WILLIAMSON COUNTY, TEXAS

CHANGE ORDER NUMBER: 1

**Bounds Street Improvements (Thrall)
Williamson County Project No. 21IFB15**

Change Order No. 1

-PROP GROU

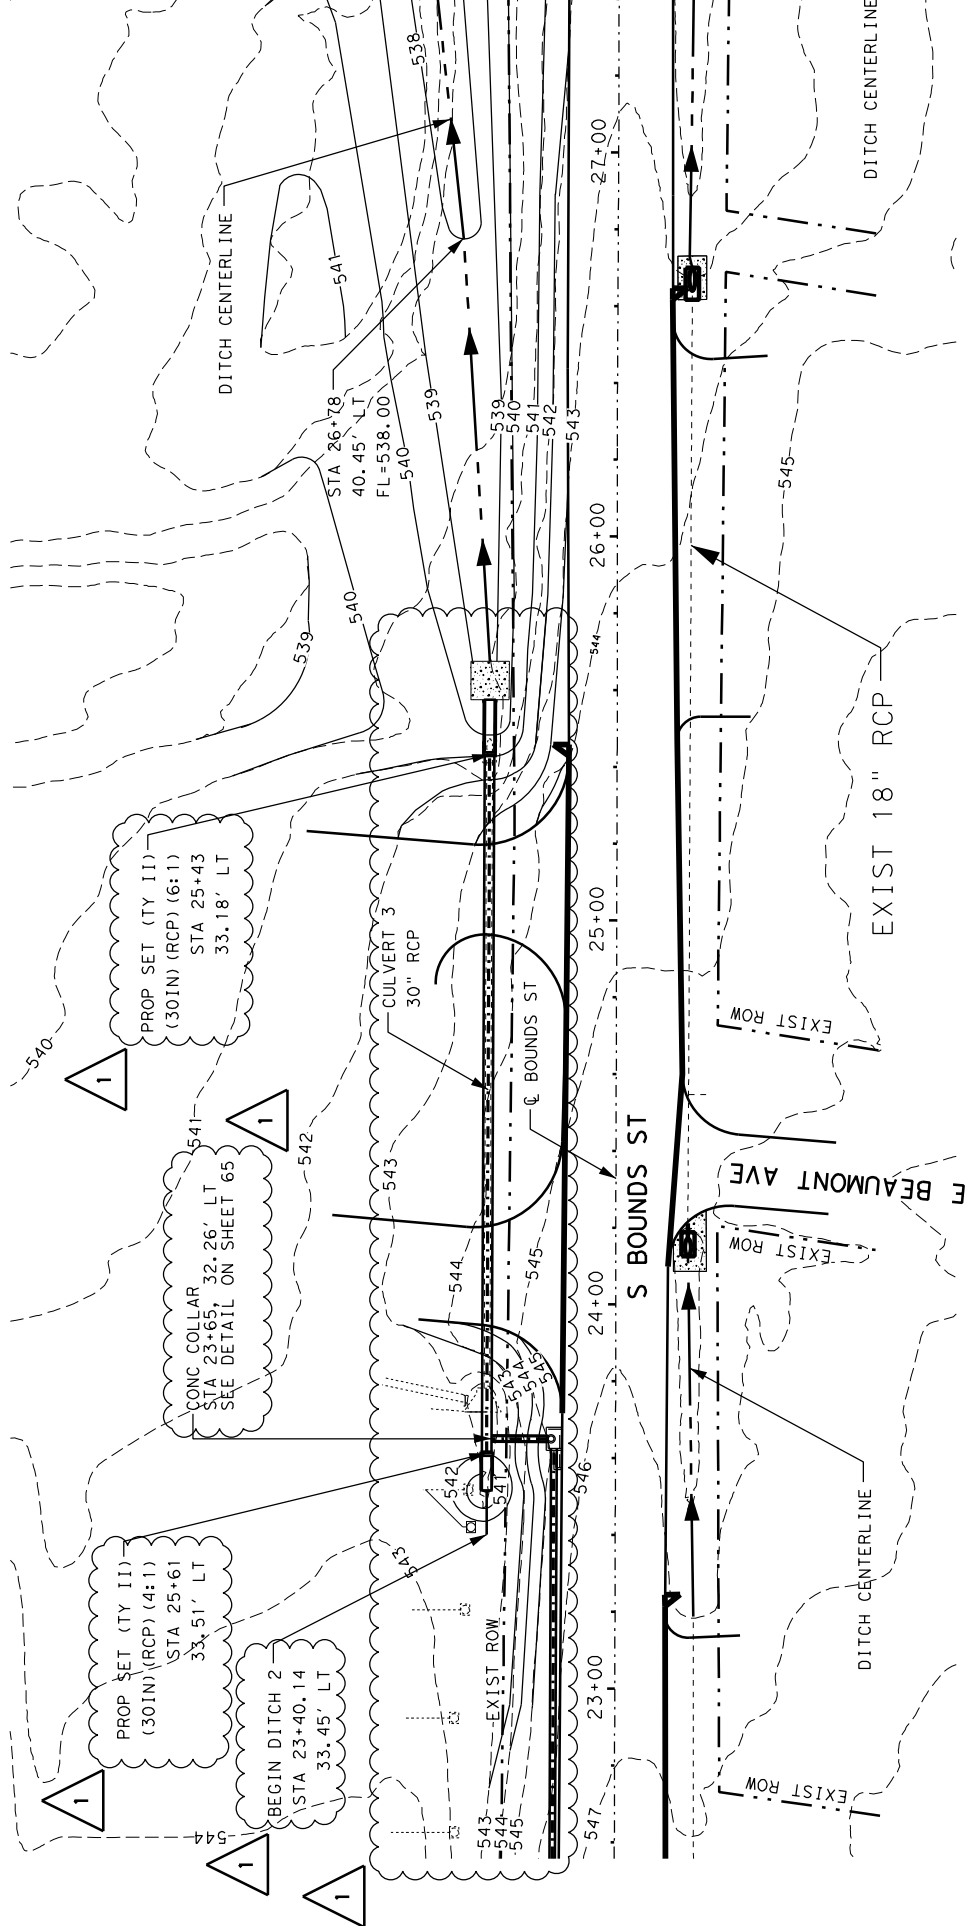
This Change Order revises the location of the drainage pipe and curb inlets to clear existing utilities and changes the curb inlets from PCO to PCU type inlets. PCO is an inlet with the box located behind the face of the curb. The conflict with the existing utility was located behind the curb. PCU is an inlet with the box located in front of the face of the curb. This Change Order also revises the pipe connection between the curb inlet and the pipe under the driveway and increases the quantity of pavement repair due to the current condition of the pavement.

ITEM	DESCRIPTION	QTY	UNIT
401-6001	FLOWABLE BACKFILL	150	CY
465-6030	INLET (COMP)(PCU)(3FT)(LEFT)	3	EA
3076-WC01	BLADE LAY TY B HMAC OVER PIPE	10	TON
